Rezoning Transportation Analysis

Petition Number: #2021-120

Revision Log:

General Review Information

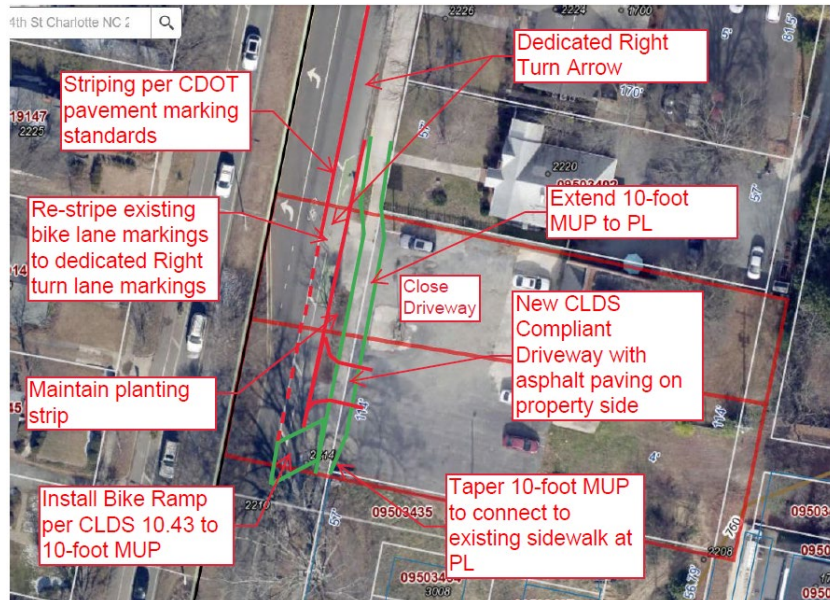
- ~~7. **Comment from 9-28-22:** Revise site plan and conditional note(s) to commit to remarking pavement markings and building a bike ramp near south property line to transition bicyclists from separated bike lanes to multi-use path.~~

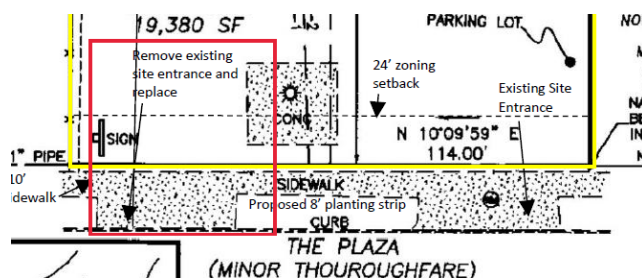
Outstanding Comment 10-26-22: After further coordination the above design has been updated as follows to. Revise site plan and conditional note(s) to commit to remarking current bike lane pavement markings to a dedicated right turn lane, a bike ramp near south property line per CLDSM 10.43 to transition bicyclists from separated bike lanes to multi-use path and extending the 10-foot multi-use path to the southern property.
